# Zen Wind Farm and associated infrastructure, Western Cape Province

Motivation for amendment of Environmental Authorisation

DFFE Reference No.: 14/12/16/3/3/2/322

July 2023

**Figure 1.1:** Layout and sensitivity map for the Zen Wind Farm presented in the Final Environmental Impact Assessment submitted in 2015 also included in **Appendix J**.

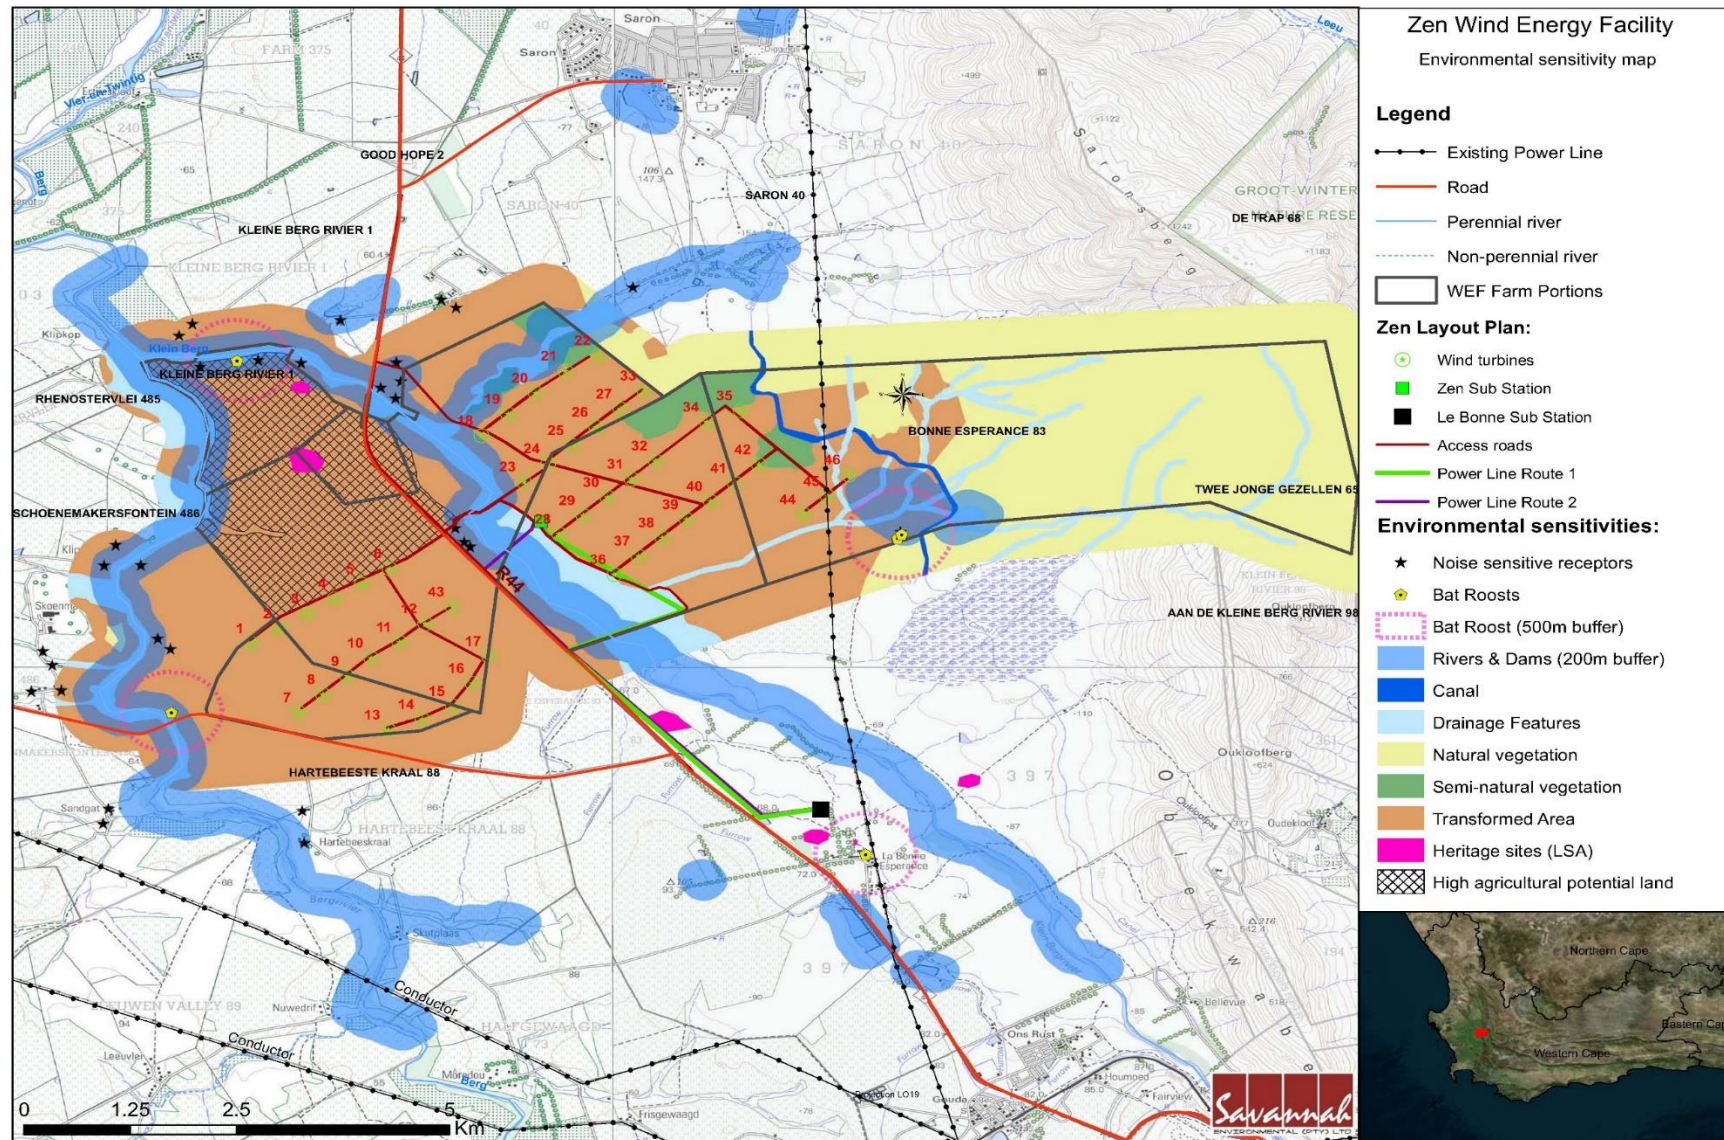
The layout presented for the Environmental Impact assessment submitted to DFFE in April 2015 is provided as Figure 1.1 and the revised Zen Wind Farm Layout showing the new 27 turbine layout amended in 2019 is provided in Figure 1.2. In accordance with Condition 13 of the EA (dated 3 November 2016), the facility layout is required to be finalised and submitted for approval. The Final layout must be made available for comments by registered I&APs and submitted to the Department for approval prior to commencement of the activity. The Amended Facility Layout Map for the Zen Wind Farm, including all identified and verified environmental sensitivities (map ref: Zen Wind Farm Amended Layout & Sens Rev2 Jul'23) is included in Section 2, and also included in **Appendix J**.

**Figure 2.1:** Amended Facility Layout Map for the Zen Wind Farm, including all identified and verified environmental sensitivities ((map ref: Zen Wind Farm Amended Layout Rev2 Jul'23 also included in **Appendix J**)

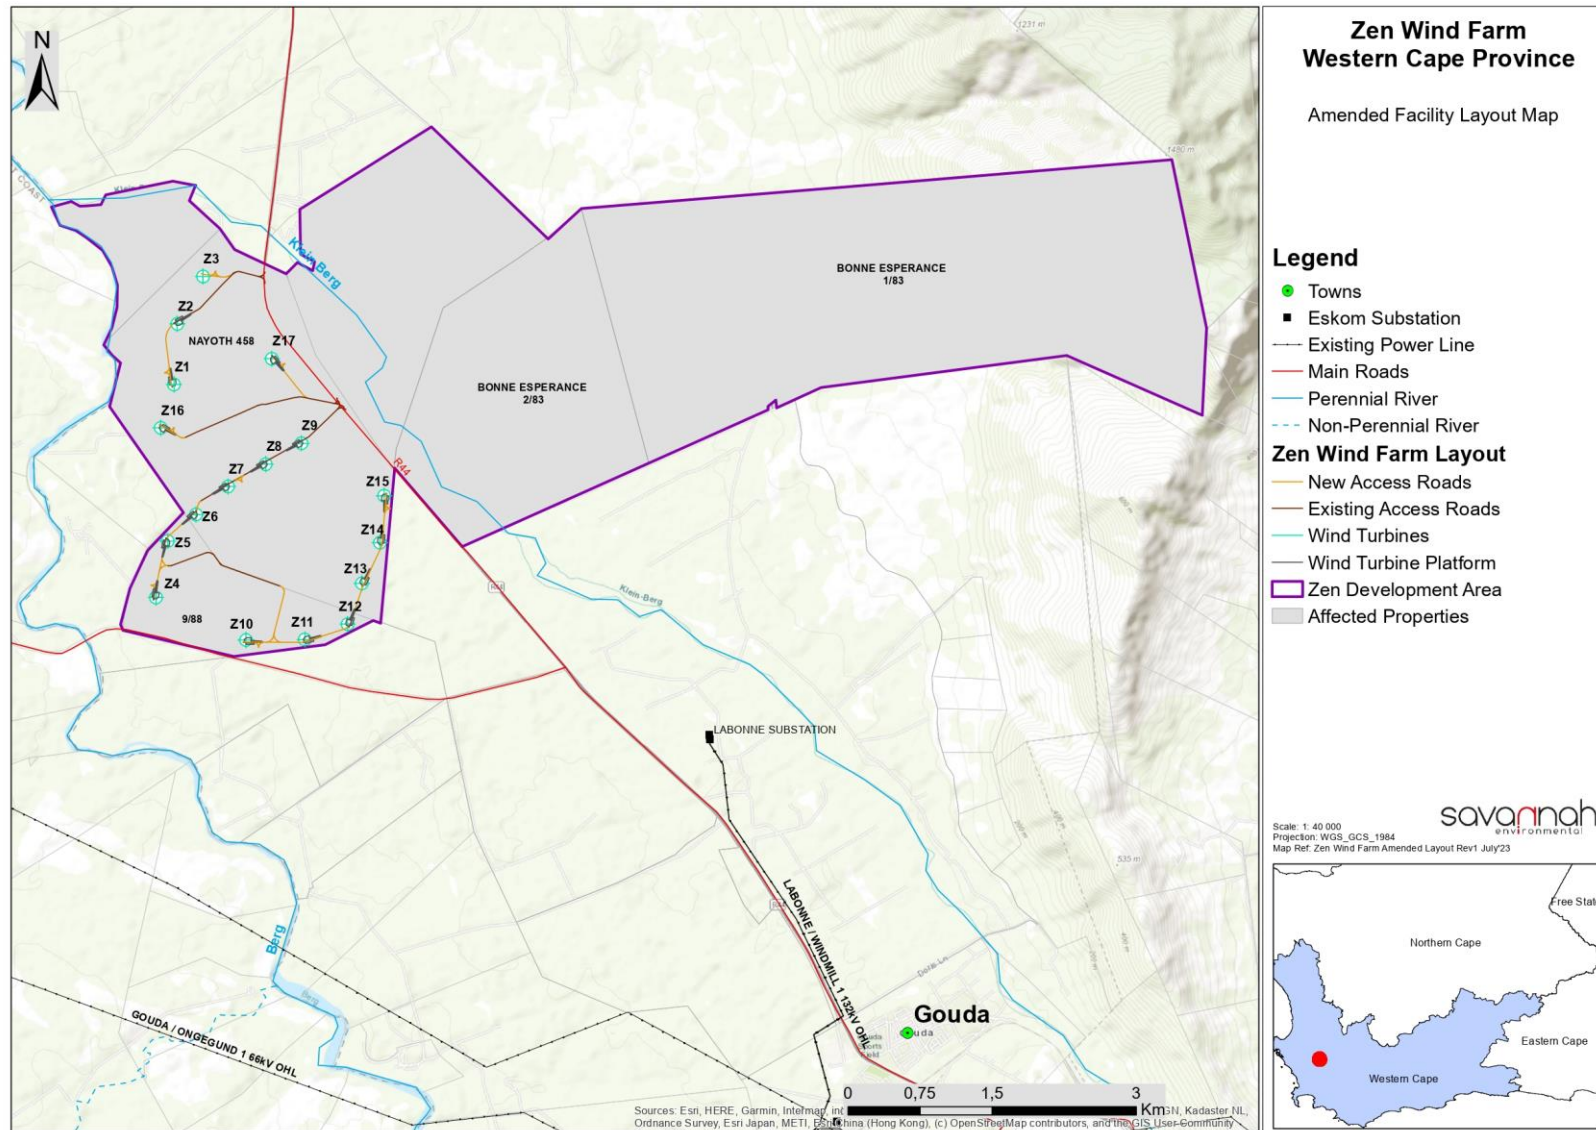
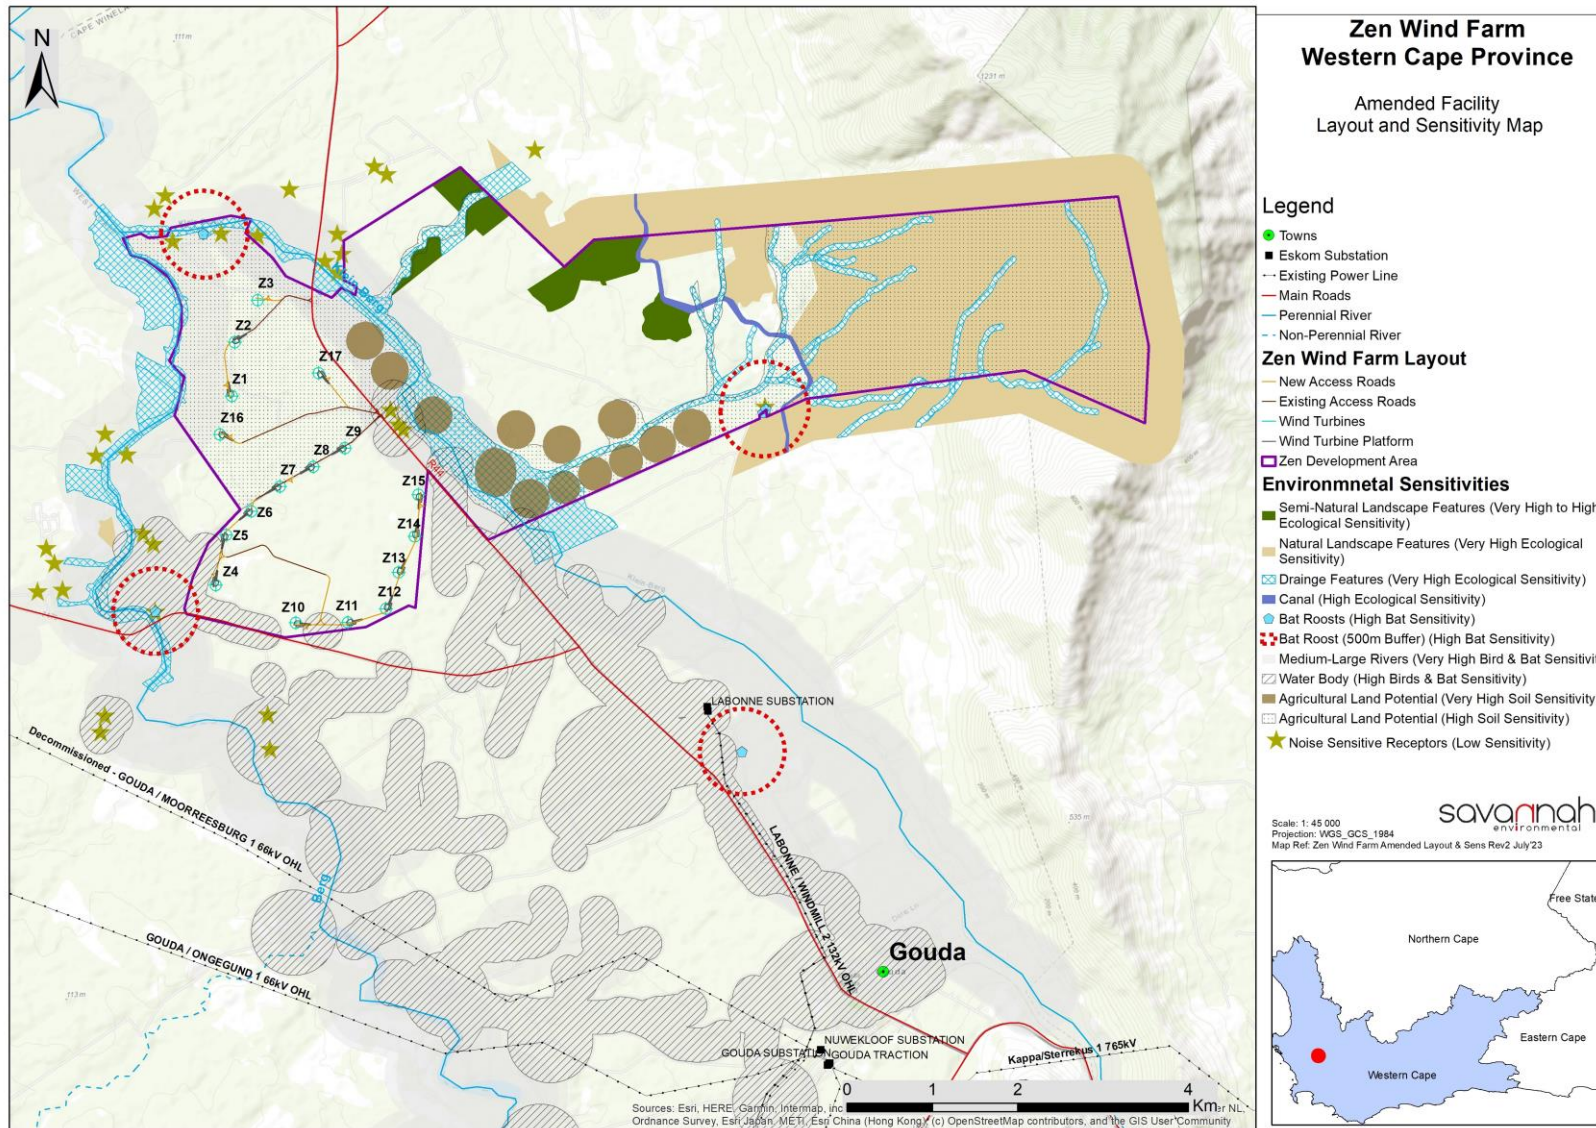
1. Reduction in the number of turbines from 27 to 17;
2. Increase turbine capacity from 6 MW to up to 7.5 MW per turbine;
3. Increase the internal roads width from 6m to ~ 8m;
4. Optimise turbine/facility layout based on the energy yield, and revise the layout as required based on the revised turbine numbers and turbine specification; and
5. Optimise internal underground cabling (33kV) to enable a consolidated point of grid connection for the Zen/Bergriver wind farm cluster on the Bergriver site and remove the on-site substation and overhead power line connection from the project description.

The amended facility layout considering these amendments is illustrated in **Figure 2.1** (map ref: Zen Wind Farm Amended Layout Rev2 Jul'23). The amended Zen Wind Farm facility layout and sensitivity map is presented in **Figure 2.2** (map ref: Zen Wind Farm Amended Layout & Sens Rev2 Jul'23). The following is included on the amended facility layout map/s:

1. 17 turbine locations are clearly indicated as a larger area which include the rotor swept area.
2. The location of all associated infrastructure is included and clearly annotated. This includes existing roads (dark brown) and the new planned roads (light brown). Cabling is proposed to be along road routes.
3. All features of sensitivity (together with the sensitivity rating) are provided on the map and explained in the map legend.
4. All no-go areas as well as any buffer areas are clearly indicated on the map and explained in the map legend.

**Figure 5.1:** Consolidated bat and bird sensitivity mapping for the Zen & Bergriver Wind Farms, showing the final revised turbine positions which remain outside all high sensitivity areas and buffers

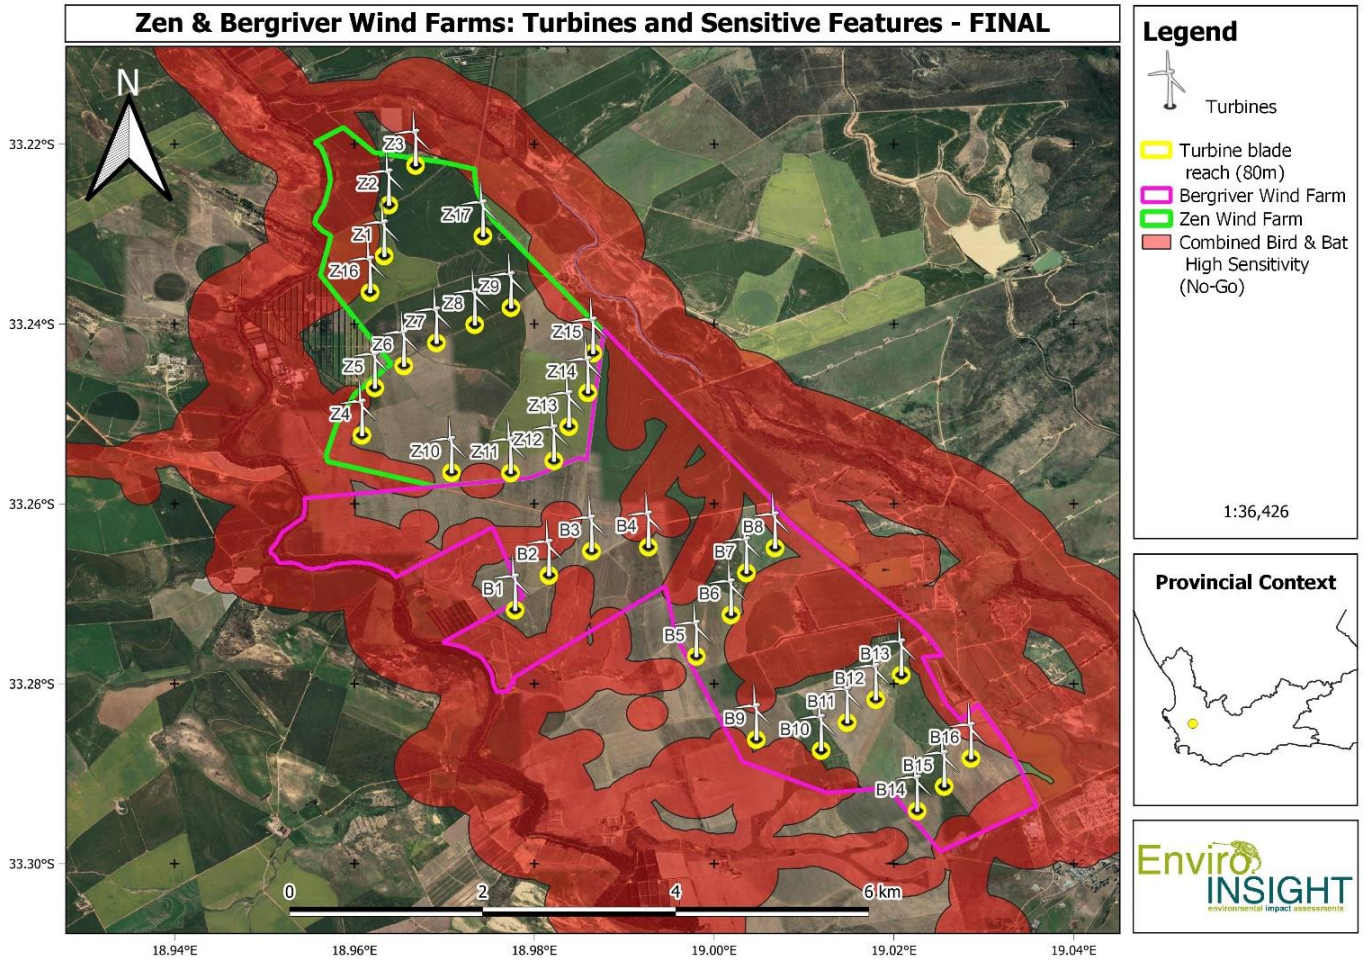
The Birds and Bat specialist report confirms that the proposed amendment to the facility layout for the wind farm will result in no change to the significance rating of the impacts of disturbance, turbine collisions, bird mortality through collision/electrocution with power lines, disruption of movement patterns, and cumulative impacts, as they have been rated previously in the specialist assessment included in the 2019 Amendment Application for the Zen Wind Farm.

**Figure 5.4:** Delineated wetlands (= Moderate sensitivity areas) and watercourses (= Moderate sensitivity areas) in relation to the activities, with buffers and the 500m regulated WULA zone.

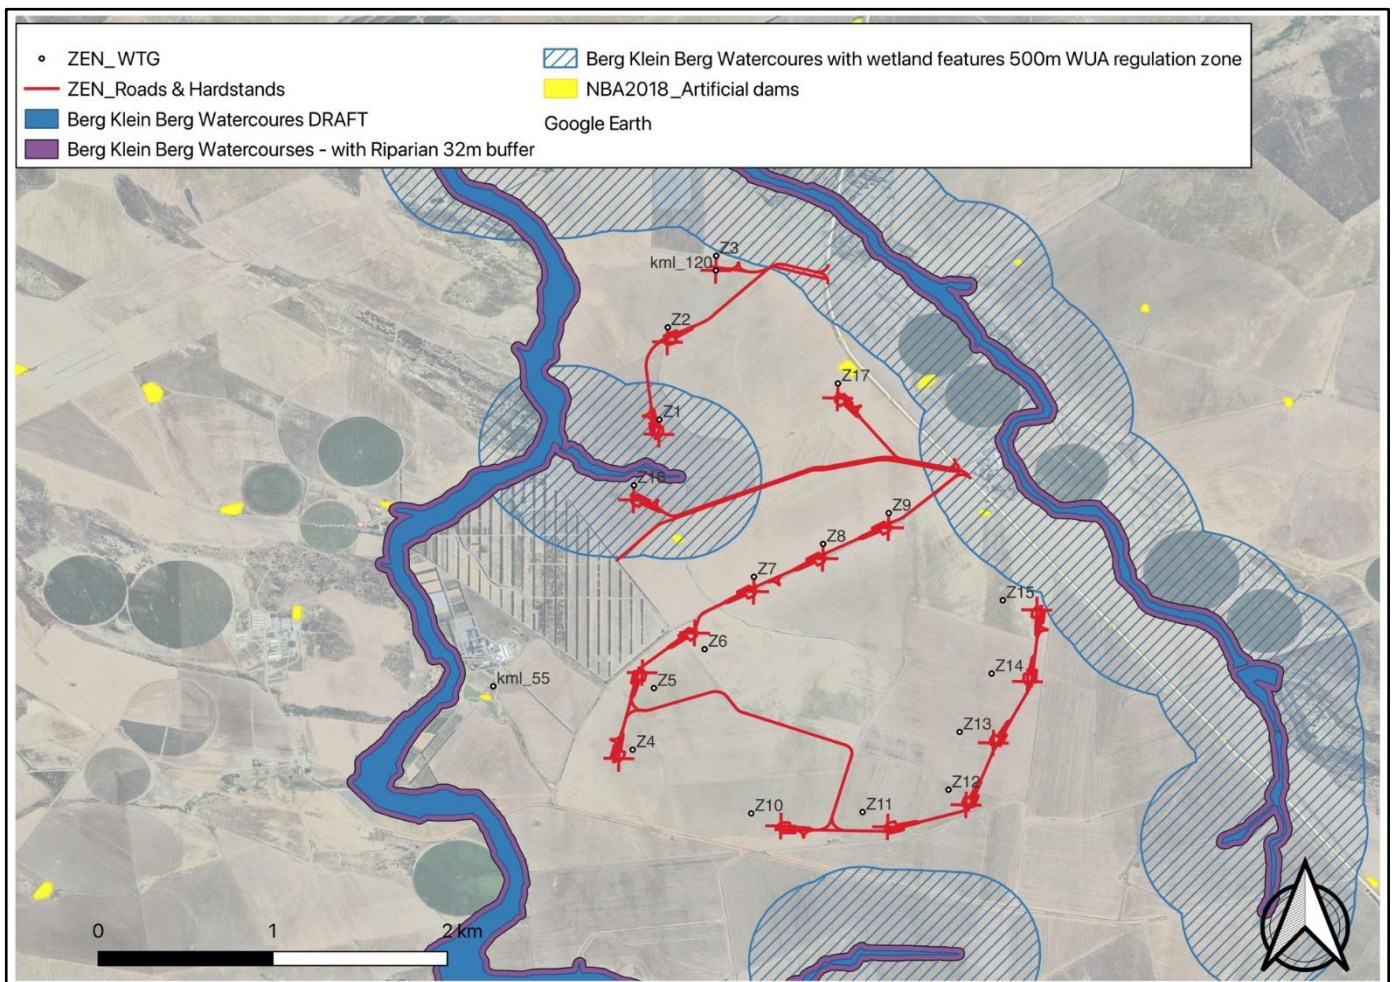
The facility layout avoids the observed systems (inclusive of the associated buffers) as these areas corresponded to the Very High Sensitivity systems considered in the DFFE Screening Tool spatial data (refer to **Figure 5.4**).

**Figure 5.5:** Amended layout for the Zen Wind Farm superimposed on the verified sensitivity

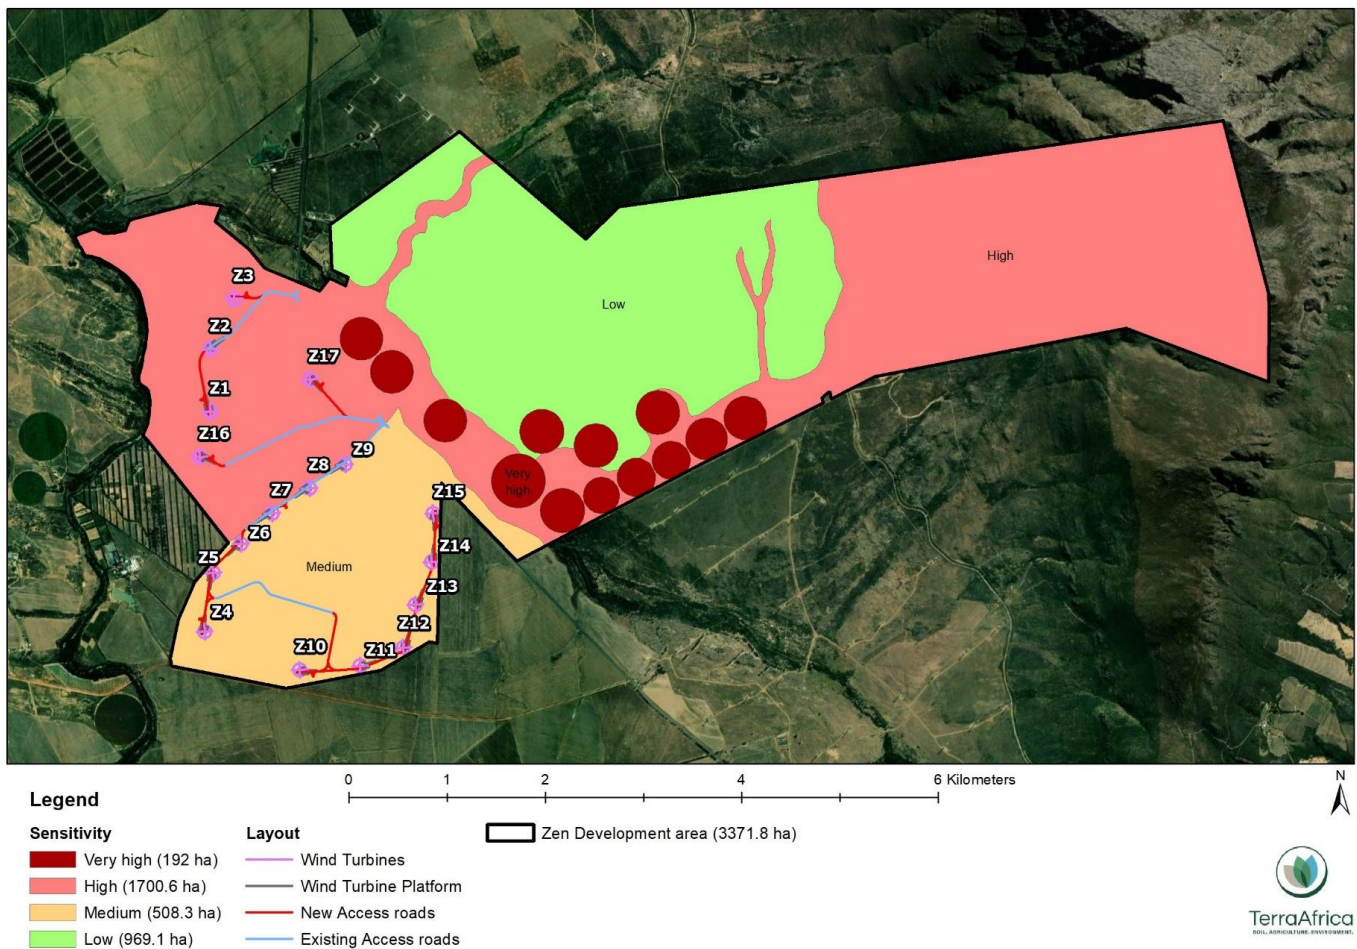
The sensitivity analysis of the assessed EIA classified the Zen Wind Farm into three different categories of agricultural sensitivity which included Low, Medium and High. **Figure 5.5** shows the amended facility layout remains within the Medium and High sensitivity. The amended layout avoids all the Very High agricultural sensitivity areas. Turbines located within areas with soils of high sensitivity are considered acceptable for development (refer to allowable limits as discussed below). In addition, roads existing in this area, and can be readily used for accessing the planned turbine locations.

The verified sensitivity delineation of the surface footprint area differs from the agricultural sensitivity as provided by the screening tool. According to the screening tool, the largest part of the area consists of land with High agricultural sensitivity because of rainfed crop cultivation and Moderate-High (Class 09 and 10) land capability. The baseline information on soil and agricultural potential as discussed above, only partially agrees with this rating and indicates that the southern part of the site should rather be rated as Medium sensitivity.
